To: INCITS Technical Committee T10
From: Fred Knight, Network Appliance, David L. Black, EMC
Email: knight@netapp.com, black_david@emc.com
Date: 14 January, 2009
Subject: SBC-3 Thin Provisioning Commands

Revision 10 [08-356r5] (Jan 15, 2009)

Figure B – Logical Block State Transitions

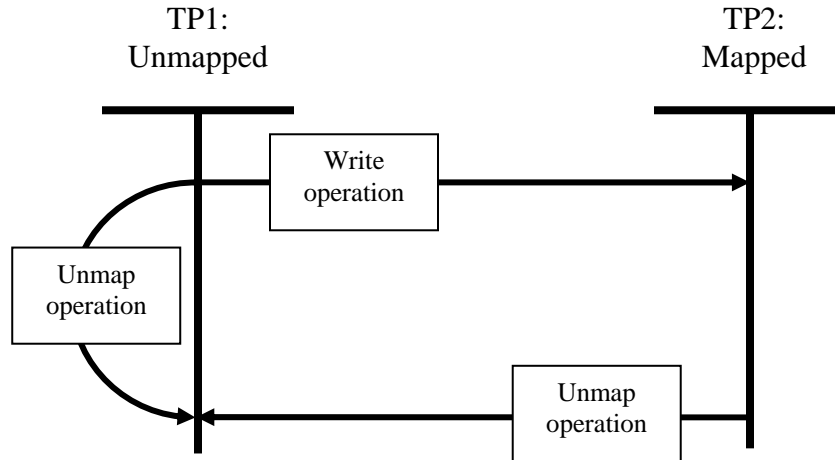
Transitions between the mapped and unmapped state are shown in figure B.

4.4.1.2 TP2: Mapped state

4.4.1.2.1 Transition TP2:Mapped state to TP1:Unmapped state

This transition shall occur when an unmap operation completes without error on a mapped LBA (see 4.4.1.5.2). As a result of this transition, the user data retrieved by the next read operation may be indeterminate unless otherwise specified (e.g., see the TPRZ bit in READ CAPACITY (16) parameter data (6.4.3)).

4.4.1.3 TP1: Unmapped state

4.4.1.3.1 Transition TP1:Unmapped state to TP2:Mapped state

4.4.1.3.2 Transition TP1:Unmapped state to TP1:Unmapped state
